PLANNING, ZONING, & BUILDING DEPARTMENT
PZ&B Staff Memorandum: Town Council Development Review

SUBJECT: ZON-22-122 (HSB-22-011) 141 AUSTRALIAN AVE (COMBO)

MEETING: JUNE 14, 2023

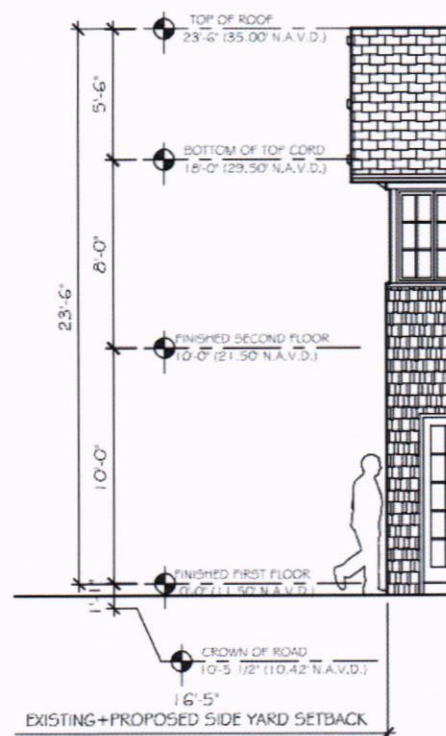
The parcel is located within the FEMA X zone, which is a Non-Special Flood Hazard Area of moderate to low risk. FEMA does not prescribe a finished floor elevation for this zone, but the parcel is relatively high by Palm Beach standards. Per the submitted plans, the building's finished floor height will be increased with a new foundation from an elevation of 10.96' NAVD to 11.50' NAVD. In addition to the increased finished floor elevation, two (2) feet of additional height will be added to the structure's ground floor walls, resulting in a floor-to-floor height of 10'-0". The 2.54' increase in height is most evident in the elevation drawings, provided on Sheets 19-20 of the architectural plan set.

Sheet 19, Existing South Elevation
 Finished Floor Elevation: 10.96' NAVD
 Height (From FFE to bottom of top chord): 16'

Sheet 19, Proposed South Elevation
 Finished Floor Elevation: 11.50' NAVD
 Height (From FFE to bottom of top chord): 18'

Because the applicants are electing to increase the height of the building's finished floor elevation and wall height for a reason other than FEMA compliance, the application will require the same variances initially necessary to reconstruct the building, with modifications to variance amounts. Staff contends that the building could be rehabilitated with a new foundation without increasing the height of the building, and therefore eliminating the need for all five variances.
